Access Compliance Report

Public Rights-of-Way

(Curb Ramps)

Intersection ID: 28322	Main Street: ARDREY_KELL_RD	Cross Street: BEAU_RILEY_RD	Location: NE
ADA ID: F9A177BCFBC1	Ramp Type: PerpDiag	Initial Pass/Fail: Pass	Overall Compliance: No
Codes/Mitigation Info/Possible Solution			Severity Score: 15
			Field Measurements/Component Compliance

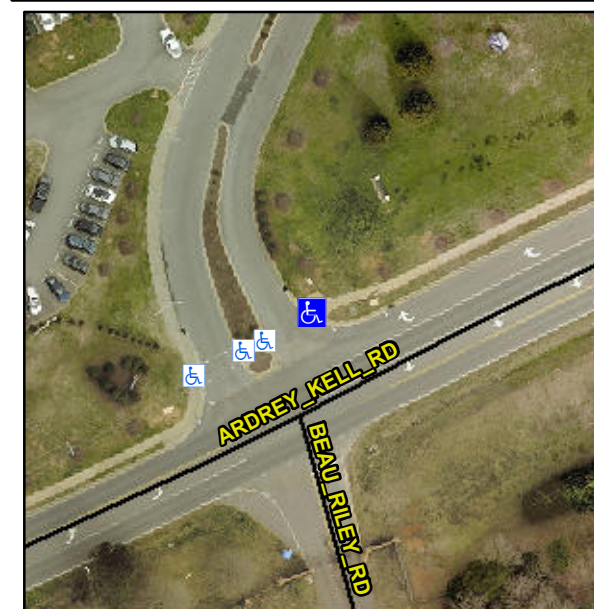
R304.2.2-Perp, R304.3.2-Para, R302.7.2

Remove & Replace Landing. Grind Gutter Lip.
